World Forum for Harmonization of Vehicle Regulations

Proposal for the 05 series of amendments to UN Regulation No. 95 (Lateral collision protection)

Submitted by the Working Party on Passive Safety *

Figure 4
Example of test method using DC power supply

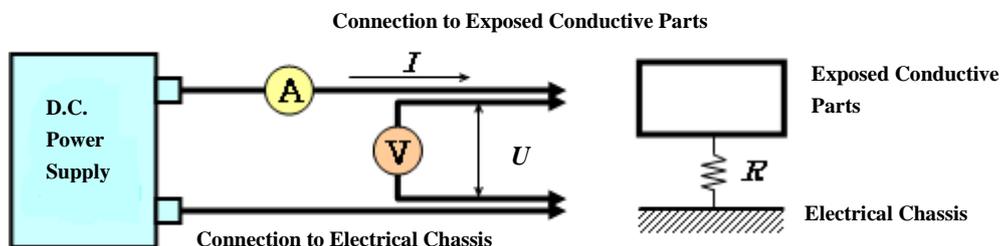
barrier) and the resistance is measured using a resistance tester that meets the specification that follows:

- (i) Resistance tester: Measurement current at least 0.2 A;
 - (ii) Resolution: 0.01 Ω or less;
 - (iii) The resistance R shall be less than 0.1 Ω.
- (b) Test method using DC power supply, voltmeter and ammeter.

The DC power supply, voltmeter and ammeter are connected to the measuring points (Typically, electrical chassis and electro conductive enclosure/electrical protection barrier).

The voltage of the DC power supply is adjusted so that the current flow becomes at least 0.2 A.

The current "I" and the voltage "U" are measured.

The resistance "R" is calculated according to the following formula:

$$R = U / I$$

The resistance R shall be less than 0.1 Ω.

Note: If lead wires are used for voltage and current measurement, each lead wire shall be independently connected to the electrical protection barrier/enclosure/electrical chassis. Terminal can be common for voltage measurement and current measurement.

Example of the test method using DC power supply, voltmeter and ammeter is shown below.

Figure 5
Measurement of U_1'

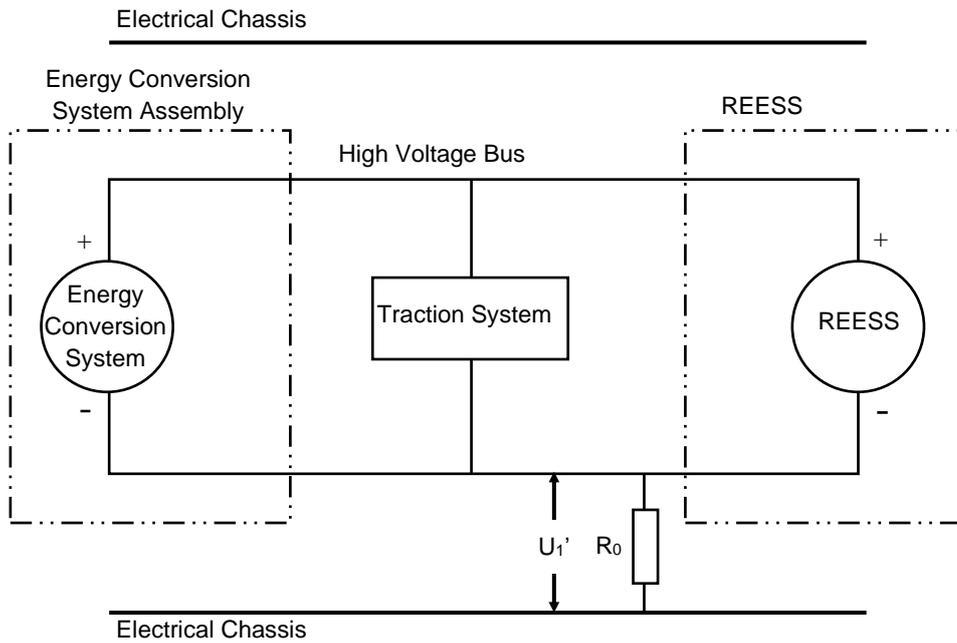
If U_1 is greater than or equal to U_2 , a standard known resistance (R_o) is inserted between the negative side of the high voltage bus and the electrical chassis. With R_o installed, the voltage (U_1') between the negative side of the high voltage bus and the electrical chassis is measured (see Figure 5).

The electrical isolation (R_i) is calculated according to the following formula:

$$R_i = R_o * U_b * (1/U_1' - 1/U_1)$$

Figure 6
Measurement of U_2'

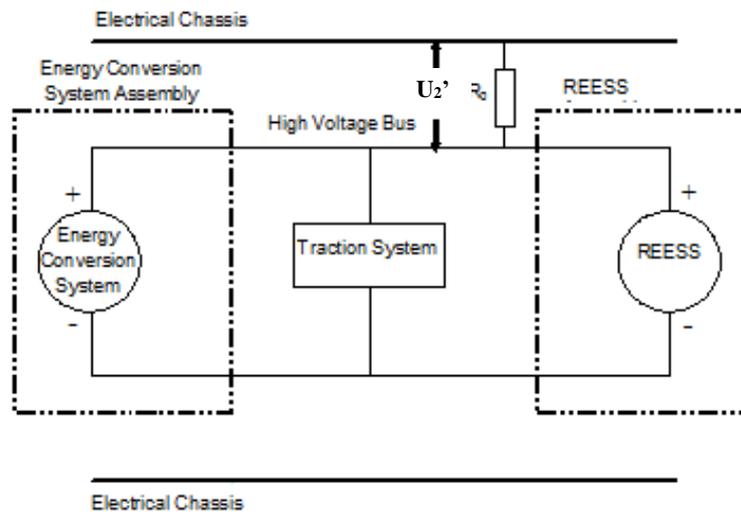
If U_2 is greater than U_1 , insert a standard known resistance (R_o) between the positive side of the high voltage bus and the electrical chassis. With R_o installed, measure the voltage (U_2') between the positive side of the high voltage bus and the electrical chassis (see Figure 6 below). The electrical isolation (R_i) is calculated according to the following formula:

$$R_i = R_o * U_b * (1/U_2' - 1/U_2)$$
